TECHNICAL SERVICE BULLETIN

Number: TSB-FC-2018-013
Symptom: Oil leak from transaxle
Date: 30/11/2018
Urgency: Low
Author: Alberto Rastelli

ISSUE: Locked drive wheel and/ or Oil leaking at the transaxle.

New shield KIT 9100002594

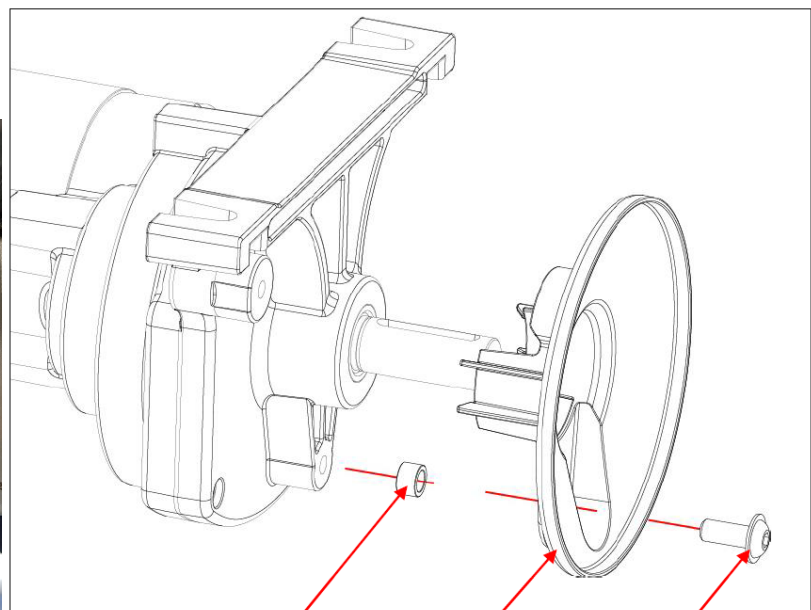
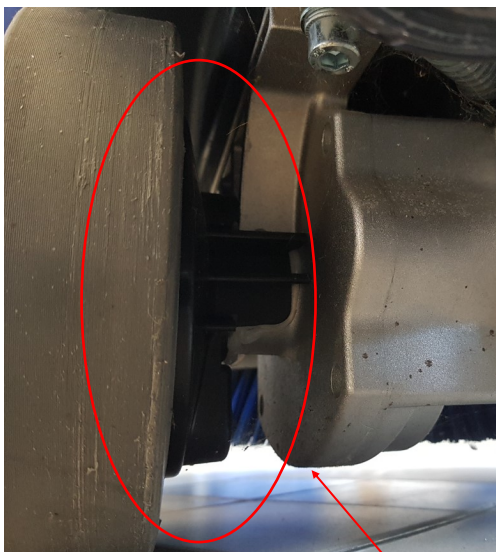
After long time usage the hair, and long fibers can roll up around the shaft and lock the drive wheel.

Add a cover for the wheel in order to avoid that the hair or the dirty push between the shaft and the bearing ball.

It is possible to improve the field SC500 scrubber reliability by adding the new shield KIT.
